NEW ELEMENTARY SCHOOL
9801 HIGHLAND KNOLLS DR
BAKERSFIELD
CALIFORNIA
93306

NEW MIDDLE SCHOOL
4115 VINELAND ROAD
BAKERSFIELD
CALIFORNIA
93306

SHEET TITLE
**ELECTRICAL MECHANICAL
PLAN BUILDING G**

E-122G

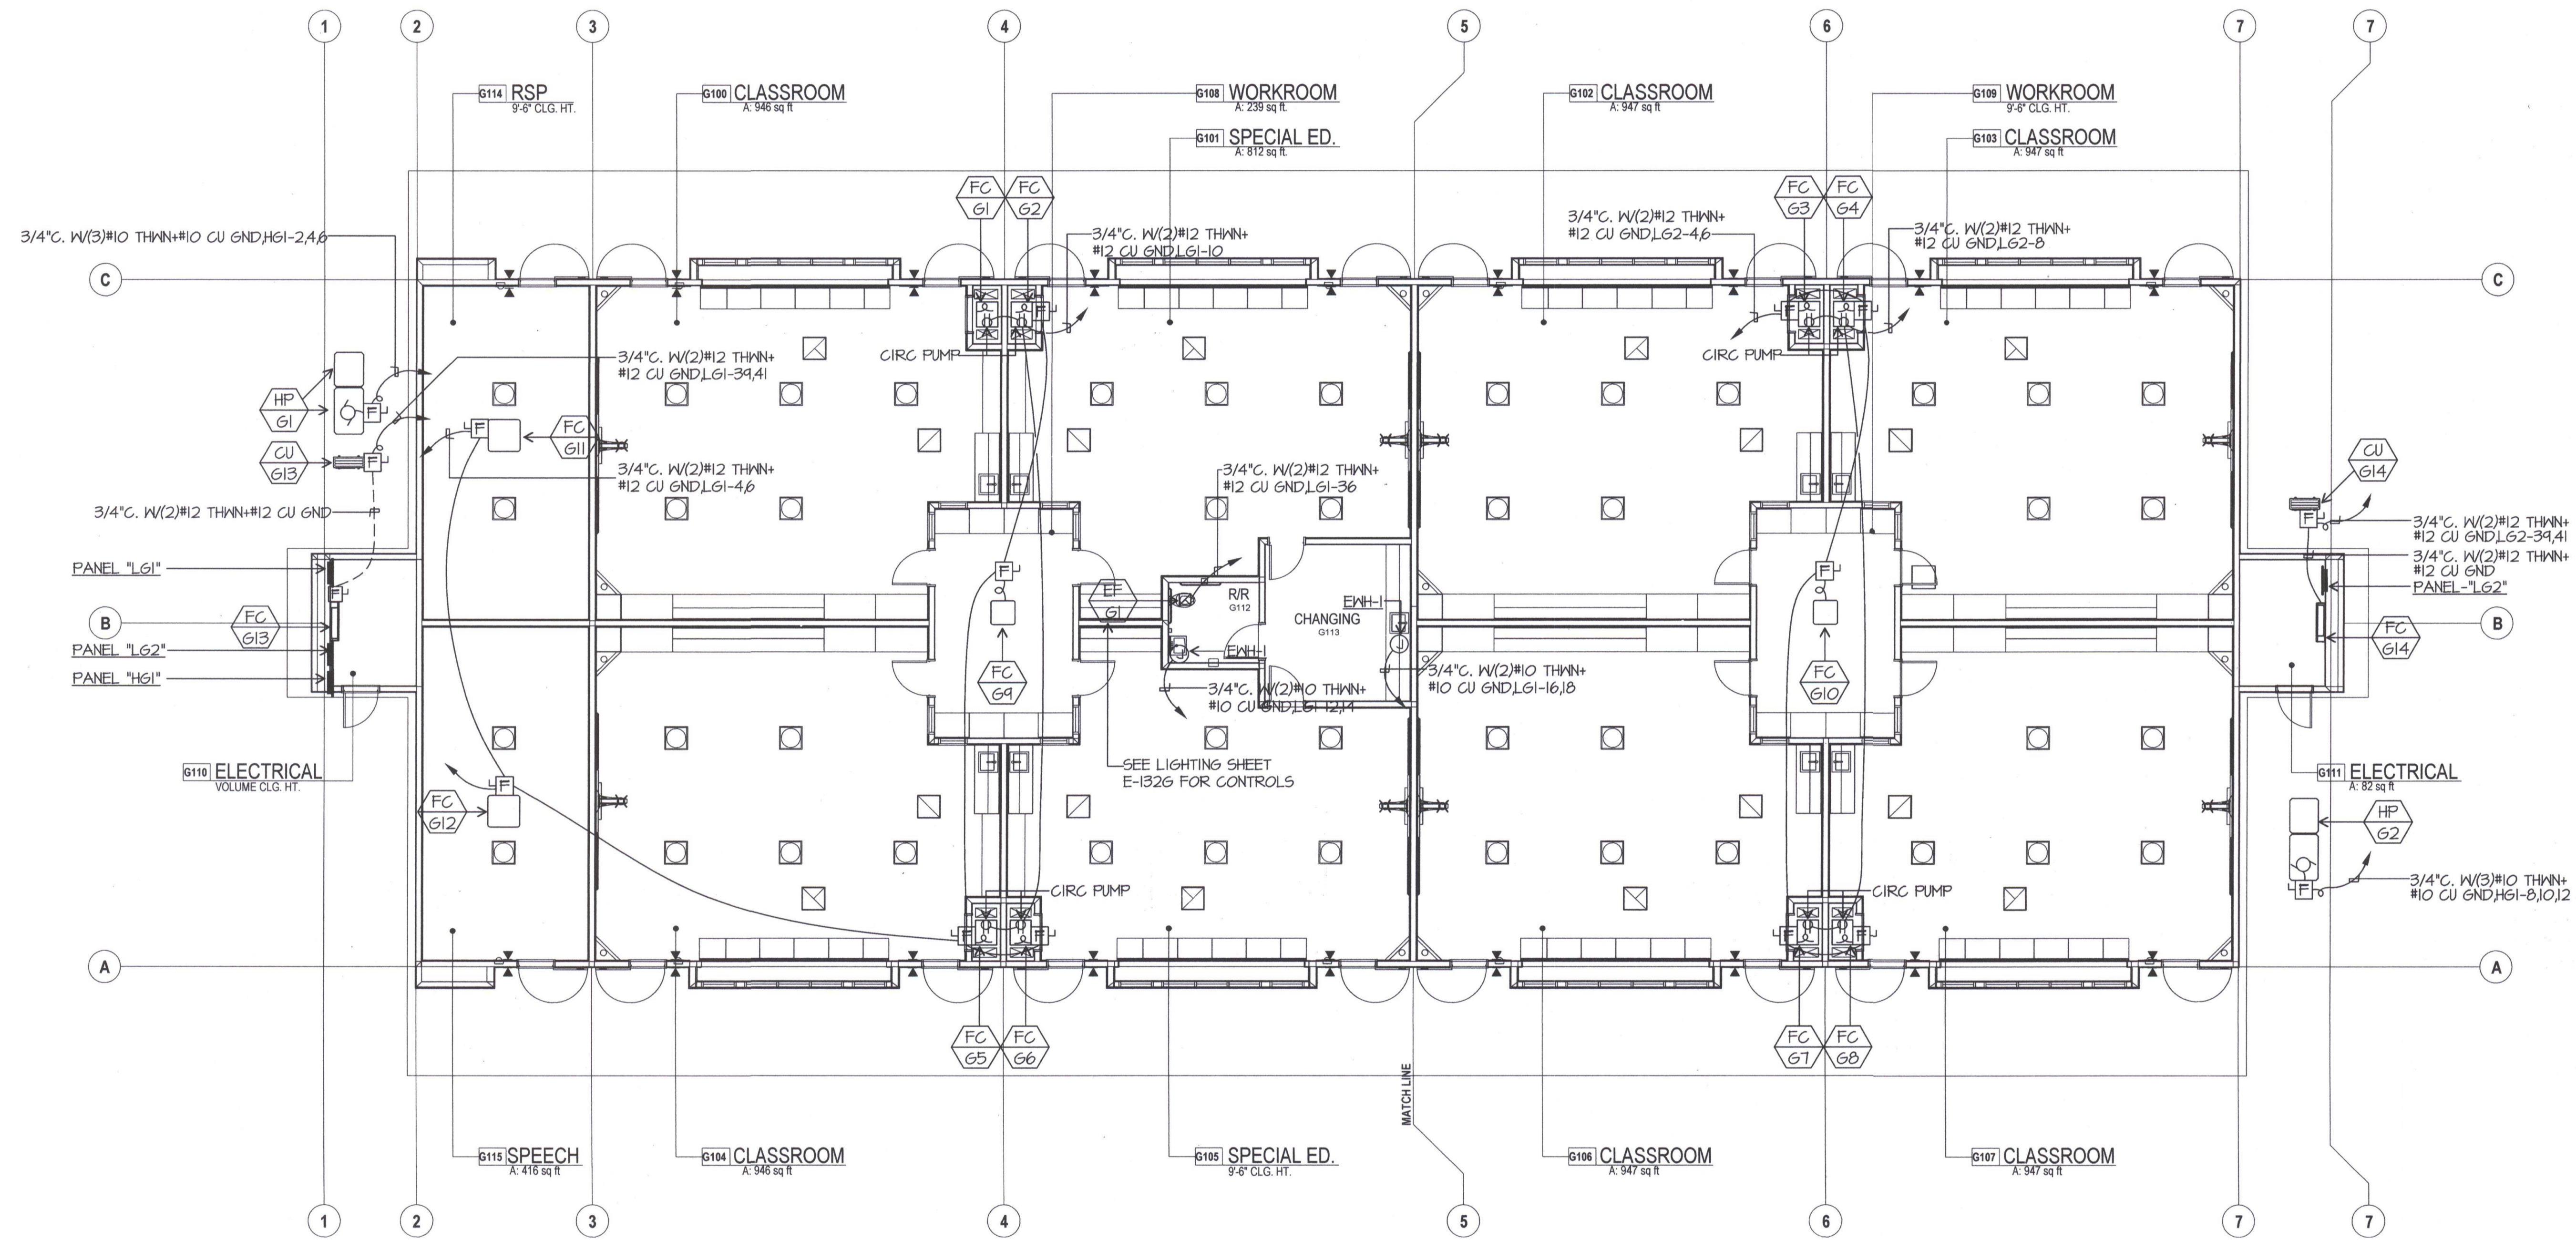
RFI 139
Request:
RDM Electric - 9/18/12
Reference Sheets E-122C, E-122D, E-122E, E-122F, E-122G, E-122H & E-122P
in the classroom buildings (C,D,E,F,G,H & I), the electrical plans show fused
disconnects to be installed for the fan coils. Due to the fan coil and ductwork,
there is not enough room to install the disconnects inside the mechanical
closets. Please advise on an alternate location for the fused disconnects for
the fan coils located in the classrooms of Buildings C,D,E,F,G,H & I.
Answer:
John Maloney - JMPE - 10/2/12
It is acceptable to mount the specified fused disconnects above the ceiling.
